Title of Change:	NCV68061 - Product robustification
Effective date:	01 Jan 2023
Contact information:	Contact your local onsemi Sales Office or Juraj.Kremmer@onsemi.com
Type of notification:	This Product Bulletin is for notification purposes only. onsemi will proceed with implementation of this change upon publication of this Product Bulletin.
Change Category:	Wafer Fab Change
Change Sub-Category(s):	New masks to increase passivation to pad metal overlap

Representative picture of the passivation to pad metal overlap increase:

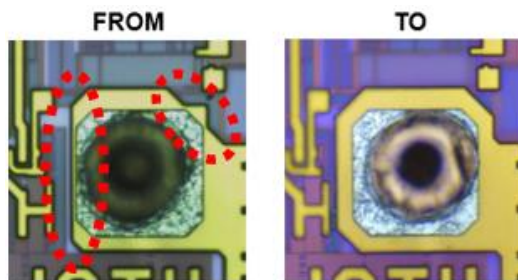
This is a product robustness improvement. In order to make the product more robust against potential issues, the passivation to pad metal overlap has been increased from minimum 2.12 um to minimum 6 um. The change is in the passivation to pad metal overlap only, done by increasing the pad metal dimensions.

No change to the bond pad opening dimensions.

No change in the pad composition and pad metal thickness.

From	To
Minimum passivation to pad metal overlap	2.12 um	6 um
